Landscape Design Review

Hinckley National Rail Freight Interchange (HNRFI)

Version 1.0
August 2023
Prepared by LUC

Hinckley National Rail Freight Interchange (HNRFI)
Landscape Design Review

HNRFI Draft Design Code V3 - page 21. Adapted to illustrate permeability.

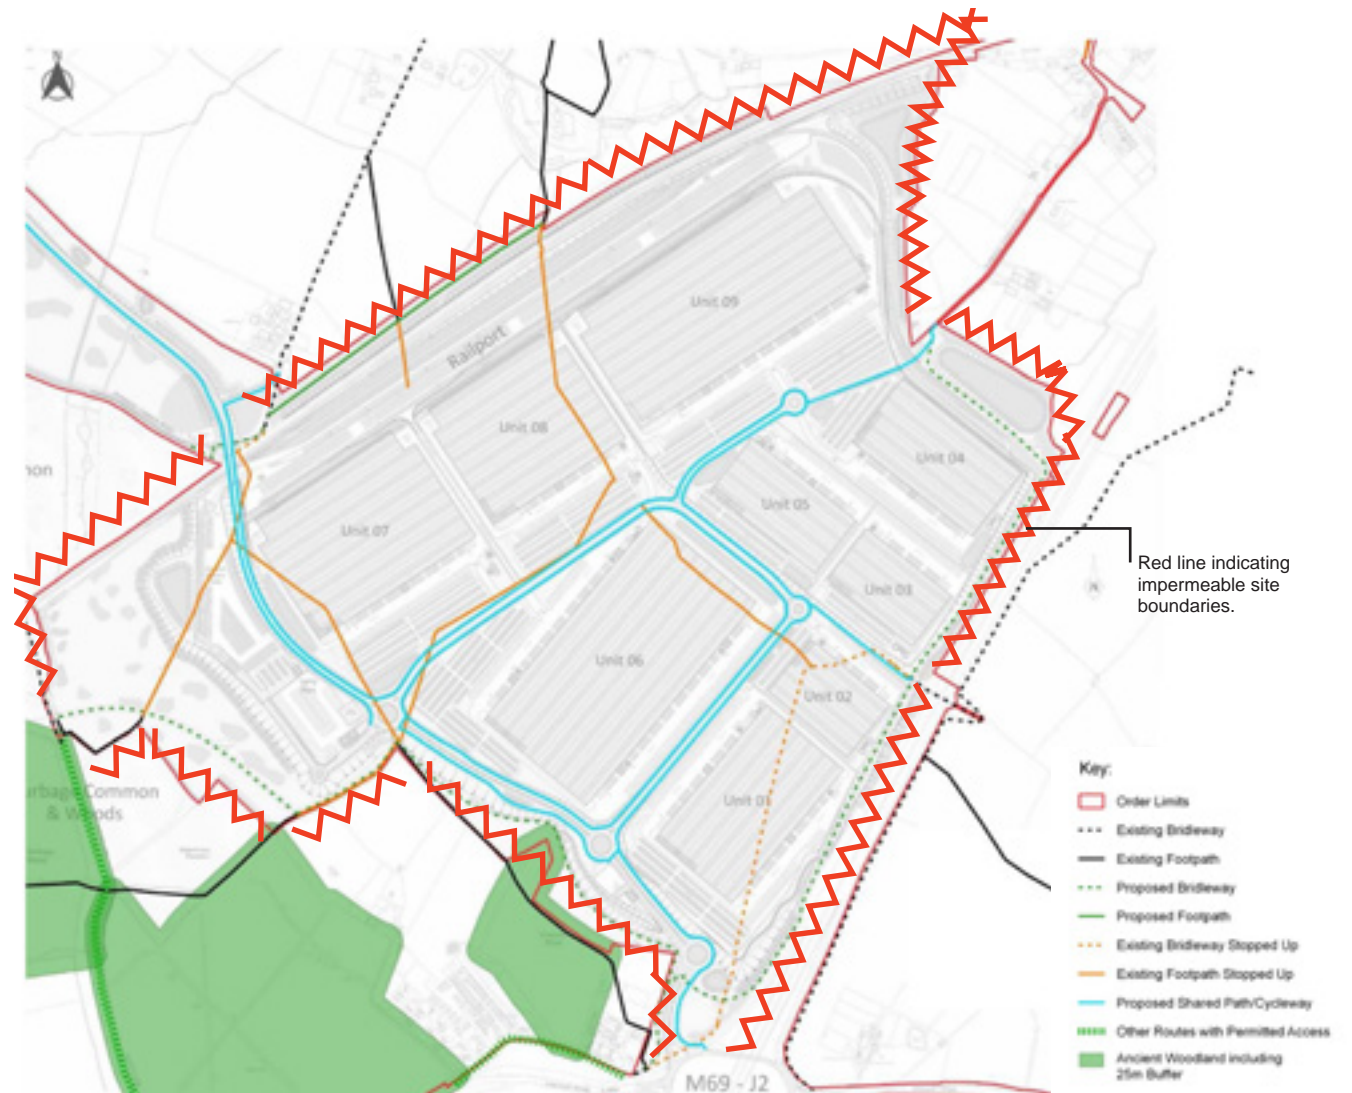
The existing public footpath and bridleways give varied rural routes permeating much of the site area. The proposals are to stop up and remove these PRow, with re-provision being on the basis of pavements and cycleways running along large main roads, which will present an entirely different character (Annex 5). A new bridleway is proposed to the south of the site away from roads, this is welcomed but does not equate to the existing provision.

Due to the scale of the built form, railport and new infrastructure such as the A47 link road there will be an increase in severance particularly impacting the residents of Elmsthorpe. Users will be able to permeate the site along the series of large main roads, which does improve access for all although these have not been proposed in a sensitive fashion. There is a focus on the proposed east - west connection to A47 and M69 but there a lack of integration and connection with the surrounding area.

The scale of the roads and hard landscaping encourages car and vehicular use, and has not been designed at the human scale for a pedestrian priority. The layout of the routes is rigid and mostly linear not conversant with the grain of the towns and villages within the wider area.

Overlay of existing of proposed development and existing green infrastructure (red). Illustrating the applicants approach to removal of the existing green assets in relation to the parameter plan.

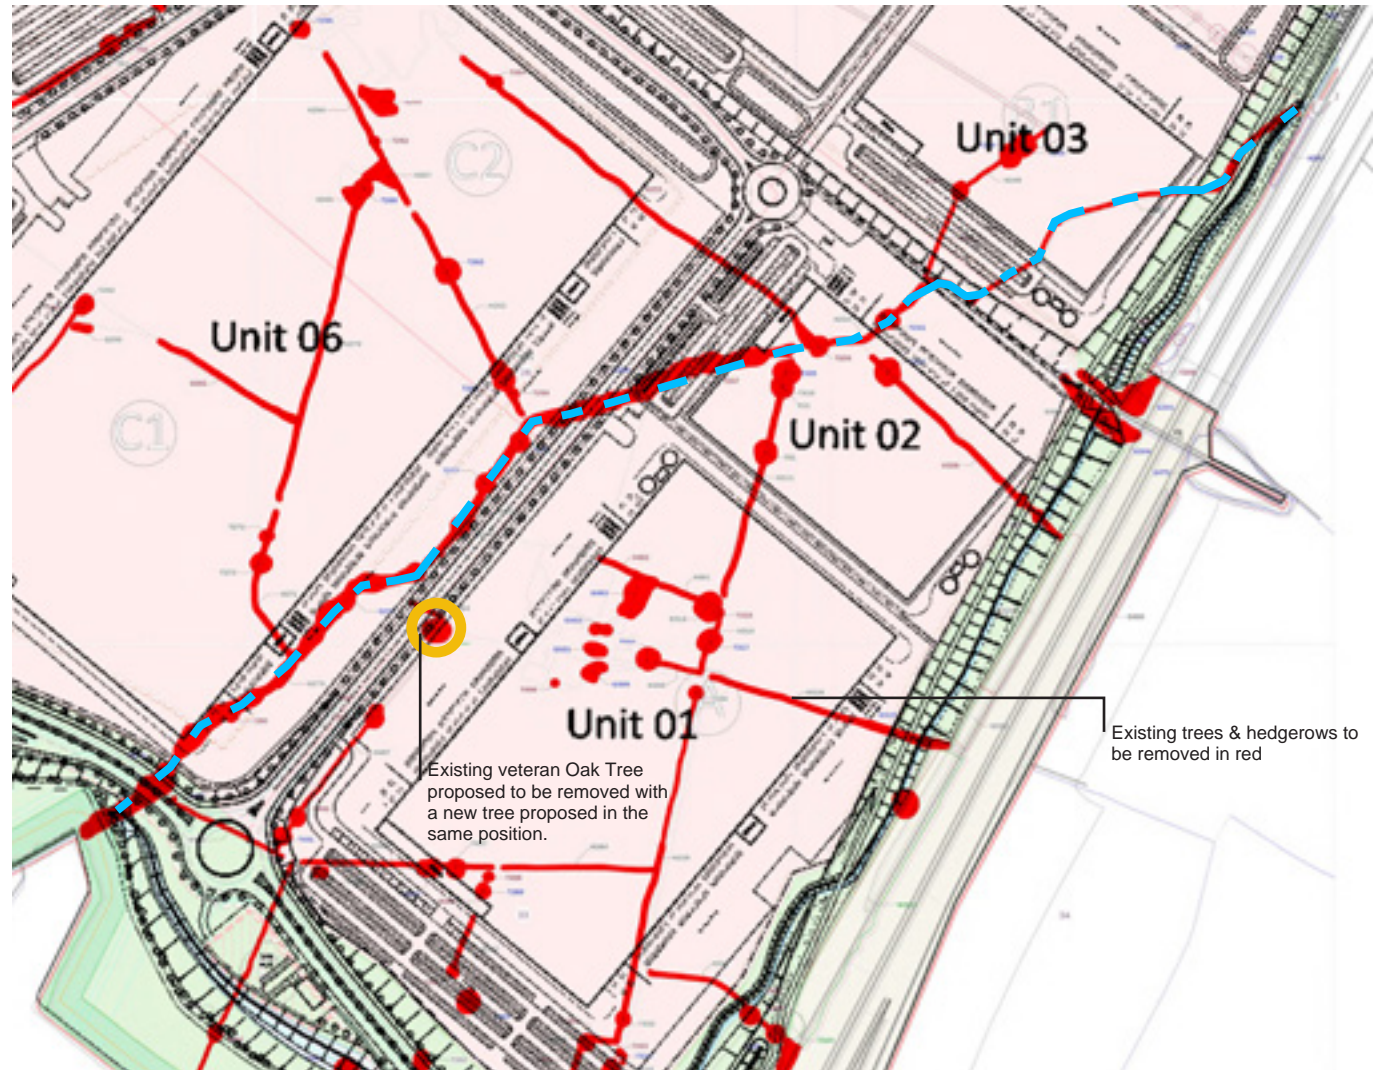
The site and adjacent area contains existing irreplaceable habitat including a T486 a Veteran English Oak which is set to be removed. Adjacent Ancient Woodland is likely to be impacted by the increase in hard standing and drainage strategy. The site area contains a large network of hedgerows which are proposed to be removed within the proposals, this will have a significant impact on the wildlife in the area.

The majority of the open space within the design (annex 2) is hard landscaped, which will cause a significant effect to the ecosystems and loss in biodiversity on site not aligning with prioritising nature. The inclusion of SuDS is welcomed but this opportunity could have been taken further in integrating into existing networks.

Extract of the applicants masterplan illustrating the heavily programmed site layout offering little opportunity for rest or amenity.

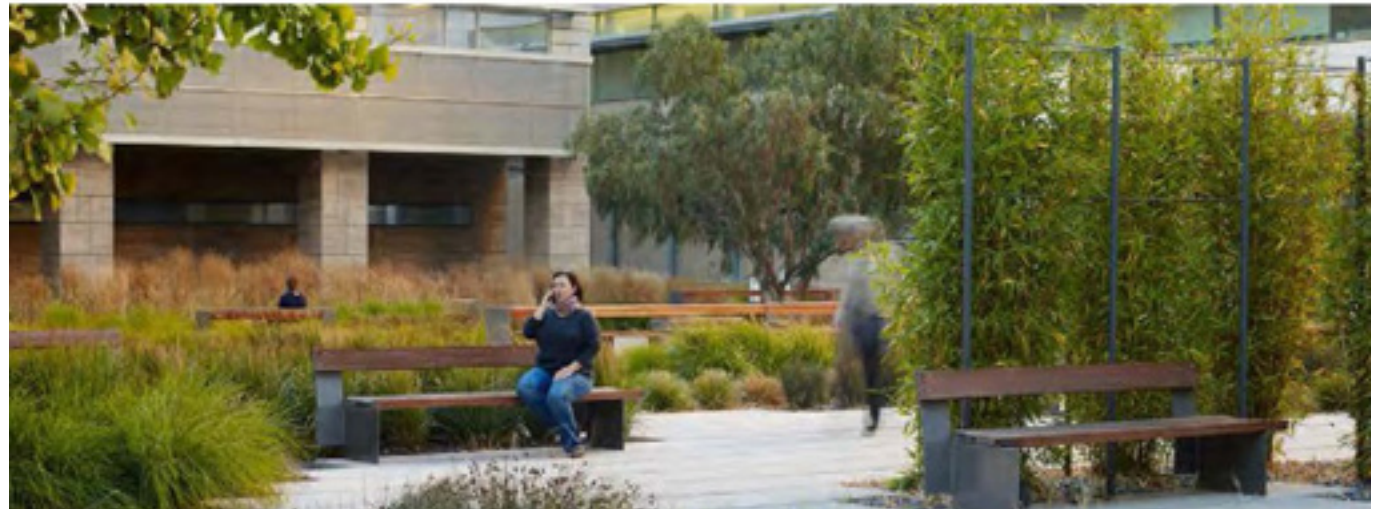
The majority of the external space has been designed solely for operational benefit, with little regard to the design of communal public spaces for amenity. The masterplan is led by the infrastructure and offers little in regard to the experience of everyday users and pedestrians passing through the site.

The road network in and out of the site dominates the spacial hierarchy, and appears to have been designed solely for functional use. The proposed green infrastructure on the road network exacerbates the linear form of the road rather than softening it. Large areas of parking lack flexibility for any secondary use or future adaptation, fragmenting the public open space and limiting wider site legibility and connectivity.

Scheme Parameter Plan

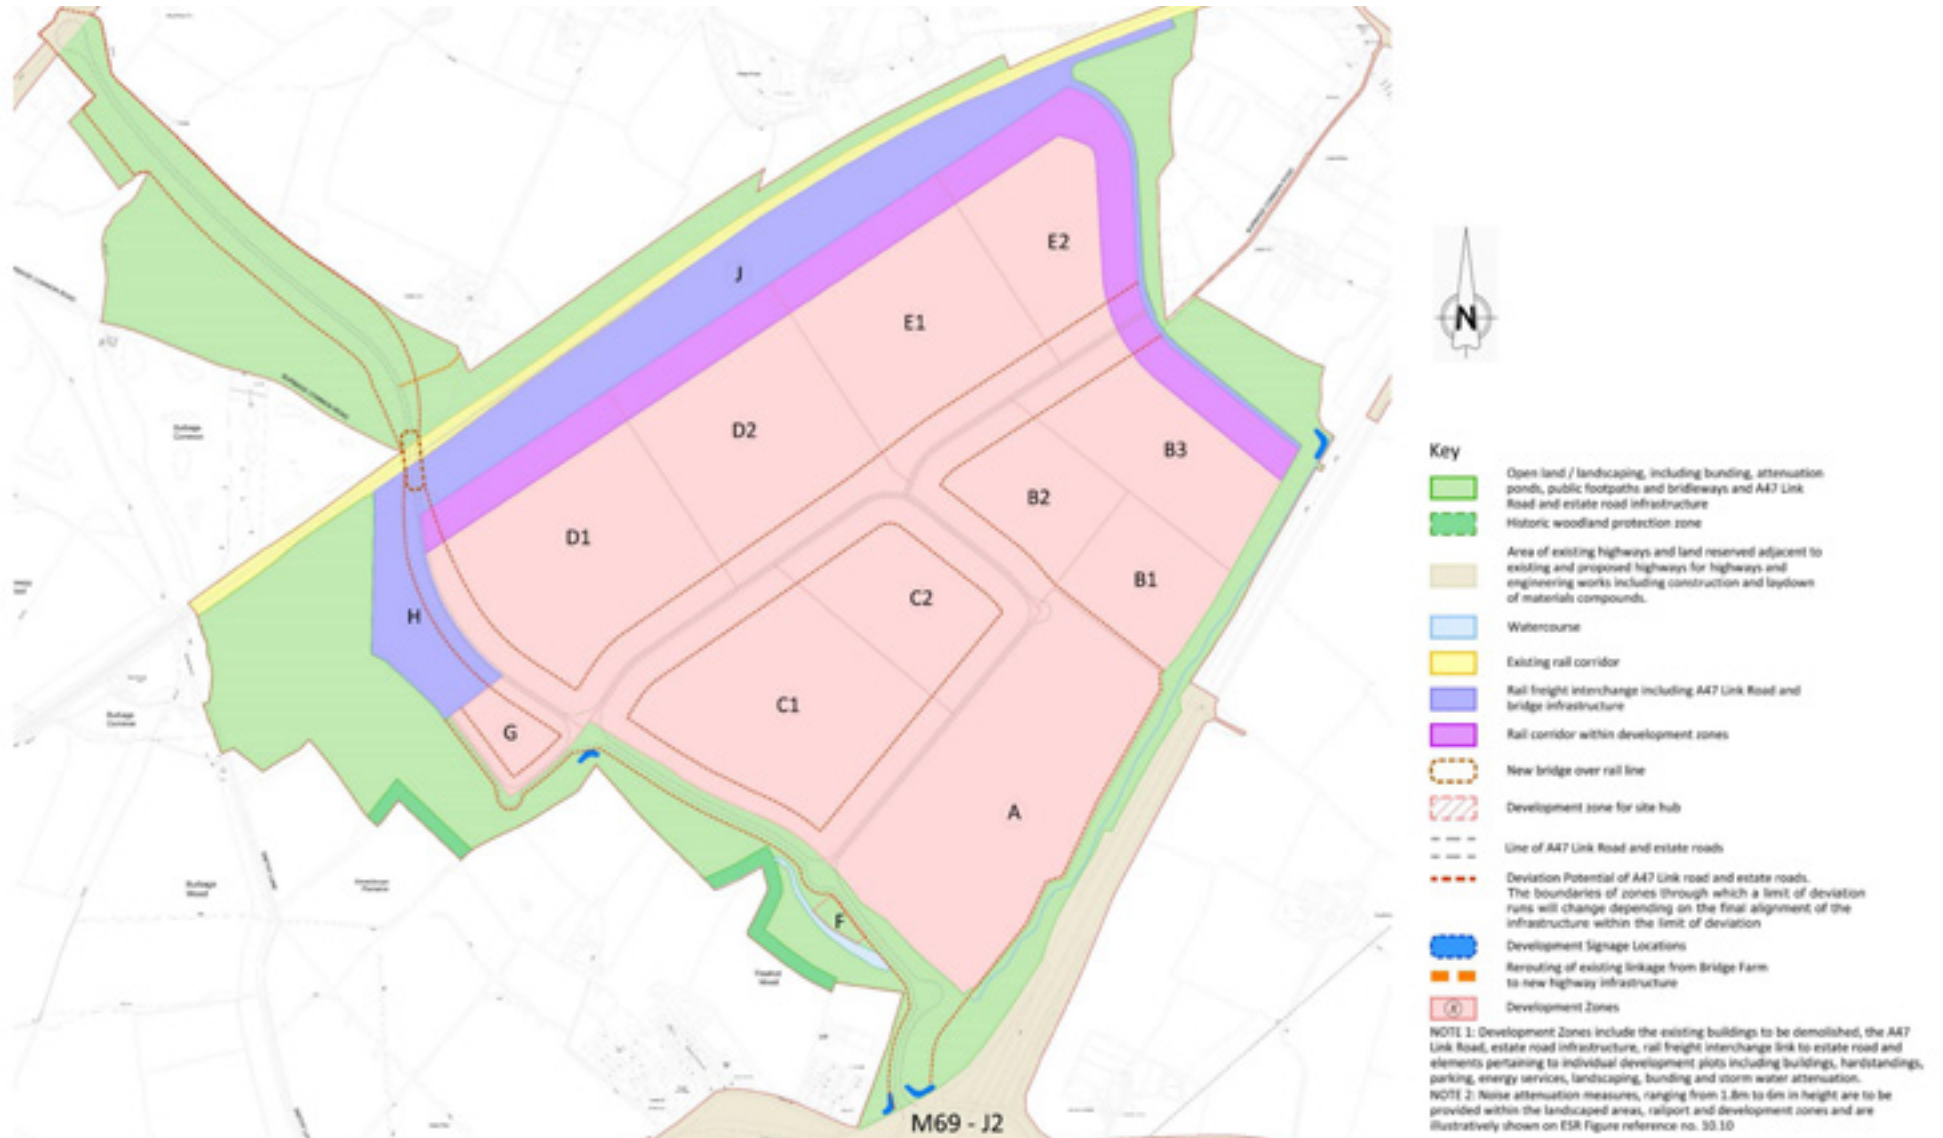
Although there has been an optioneering process to arrive at the current scheme which is welcomed, the process does not appear to have challenged the parameter plan (annex 1) which is fundamental in setting the development down it's current trajectory.

The parameter plan (Annex 1) dictates site clearance within its primary development zone. This forms the majority of the site and removes the current grain of the landscape which integrates it into its context. Without this common grain the development is rather inward looking proposing a new layout that is more uniform lacking cohesion with its surroundings.

3.6 The scale of the development is set by the parameter plan (Annex 1). This designates the primary development zone as well as areas forming a landscape buffer. The latter are in reality fringe pieces of land that due to lack of space fail to accommodate the necessary mitigation on site to appropriately screen the development. The NPS states '*the Secretary of State may decide that the benefits of the mitigation to reduce the landscape effects outweigh the marginal loss of scale or function.*' (5.159 NPS National Networks). The found significant visual effects is certainly cause to review the scale and overall density of the development that currently cannot adequately be mitigated by the landscape proposals.

3.7 The parameter plan (Annex 1) should be reviewed to ensure that proper allowances are made for green space both to buffer the development and accommodate replaced green infrastructure (if proven removal of existing is unavoidable). Currently the scale of green space provided is not conversant with the scale of the surrounding built environment. The masterplan (Annex 2) should provide meaningful green space that is integrated throughout helping to lessen the scale of proposals and soften the scheme from within as well as when viewed from the outside.

3.10 The proposals are largely formed by the parameter plan (Annex 1). All of the existing landscape features within the proposed primary development zone are proposed to be cleared (Annex 3 demolition plan). This includes a number of high value trees including a veteran Oak, a watercourse and an extensive hedgerow network. The draft NPS states *'The Secretary of State should not grant development consent for any development that would result in the loss or deterioration of irreplaceable habitats including ancient woodland and ancient or veteran trees unless there are wholly exceptional reasons...'* (5.58 Draft NPS National Networks). This is reflected in the current NPS which makes clear that the removal of veteran trees are only acceptable where loss is proven to be unavoidable. The approach to the existing green infrastructure appears dismissive of the existing and

Annex 2 Illustrative Masterplan

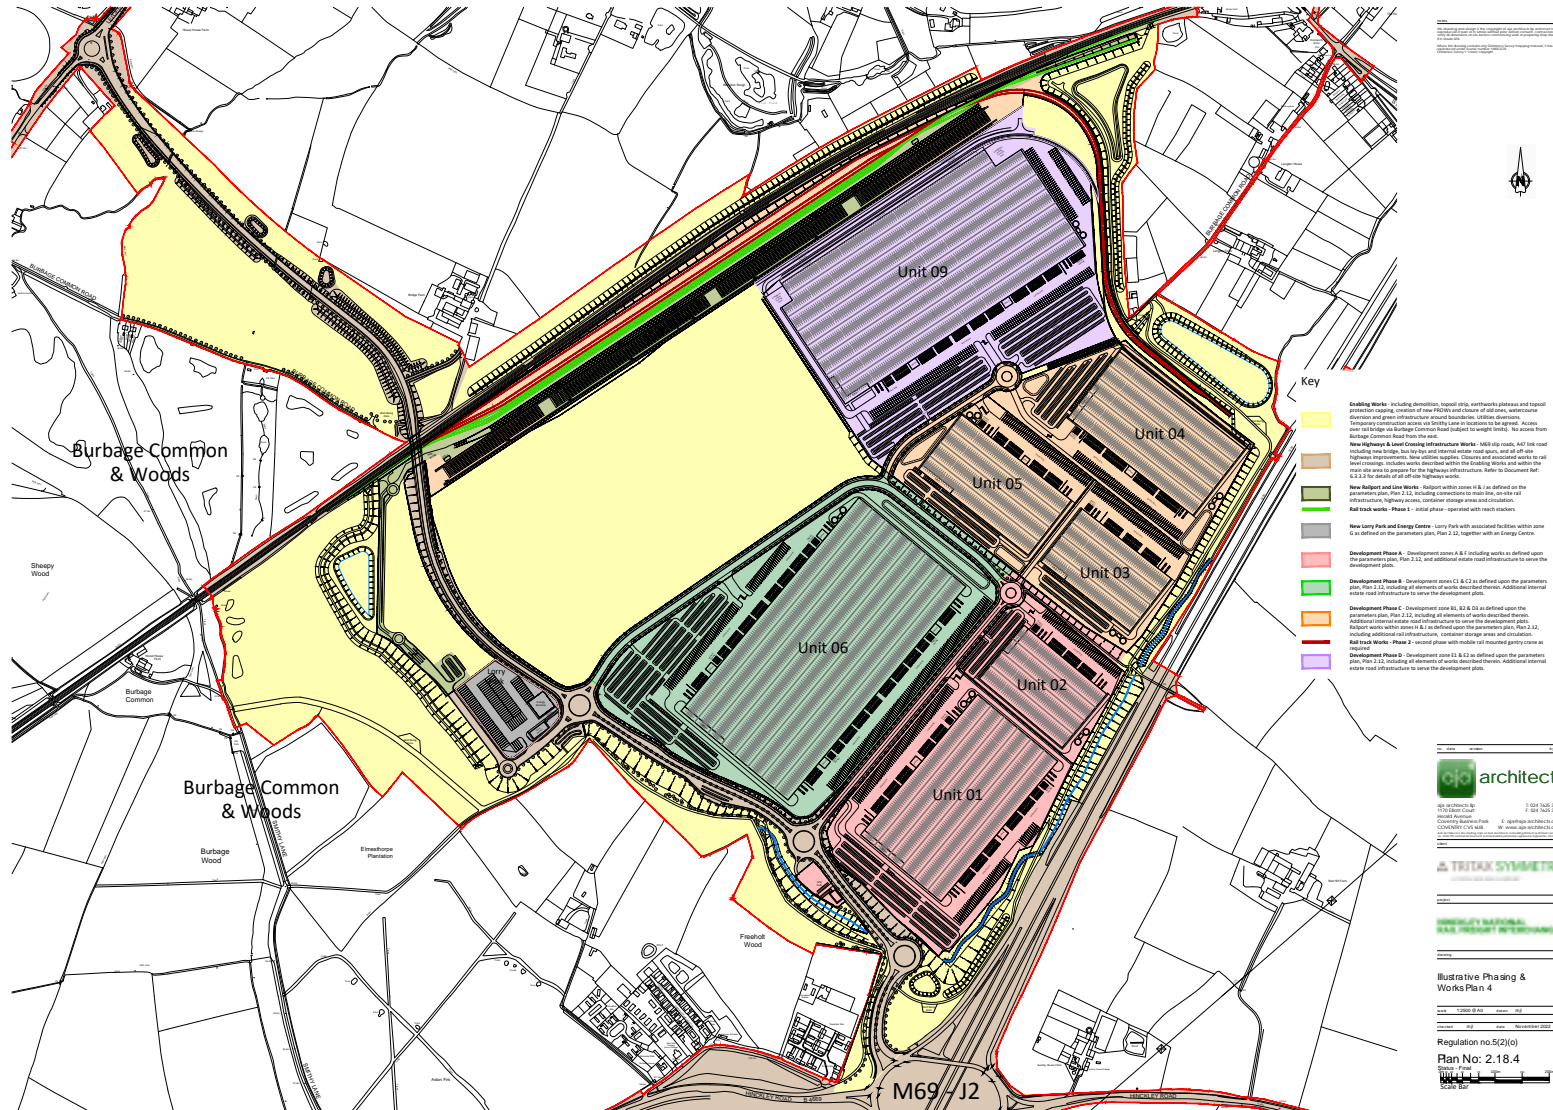
The layout (Annex 2) and architectural massing lacks hierarchy and is not conversant with the local area. The streets proposed are of a similar scale to each other with no distinct features. The streetscape lacks legibility with little means for natural wayfinding or orientation.

There is minimal provision for activities or gathering opportunities within external spaces. A few features are placed to the edge of the site such as outdoor exercise equipment and seating but these do not feel integrated to the design and appear isolated. The masterplan (annex 2) currently offers limited opportunities for social interaction.

There is very little outdoor provision for health & wellbeing integrated into the overall masterplan (annex 2), the areas of outdoor gym and seating make up a small proportion of the site and appear focused in one area. There is little integration for users and pedestrians between the buildings creating large areas of dead space.

The majority of building frontage has a sterile relationship with the adjacent spaces. Plots appear detached from one another with imposing features and little sense of a ‘human scale’. The masterplan (annex 2) has prioritised servicing and function over aesthetics. This need not be the case and more sensitive design could achieve both. Smaller associated architecture such as gatehouses are opportunities to link the proposals to the local vernacular. The proposal fails to do this giving the masterplan a cold, generic feel to users.

The masterplan (annex 2) sets out a rigid grid that is suited to its proposed intended use. Green infrastructure proposed is similarly rigid bound to the street layout or on the fringes of the site. There is little scope for this to mature into anything with significant environmental benefit in the future. With pressure from extreme climatic events the site must have the future capacity to accommodate increases in flooding without impacting neighbouring sites such as the adjacent ancient woodland, it is unclear if such a strategy is in place.

The development lacks integration into the local area and seems unlikely to develop any sense of community. The masterplan (annex 2) allows for little scope to instil a local sense of ownership.

3.2 The masterplan (Annex 2) adopts a heavily engineered approach and although logical for its primary use lacks connection to its local context. Although wider connections are made these are of a poorer spatial quality than existing. The proposed is not sufficient in '*connecting communities, addressing community severance and integrating into its surroundings*' (4.24 Draft NPS National Networks) at times it exacerbates severance particularly with the inclusion of the new link road and removal of existing PRow connections across the railway.

3.3 The applicant should reconsider the hierarchy of the streetscape creating a legible public realm that is distinct yet related to the wider area. The proposals should strengthen existing connections avoiding severance and provide an enhanced quality of the existing rural character, not diminish it. Proposals should accommodate a more diverse range of spaces giving relief to the monotony of the streetscape.
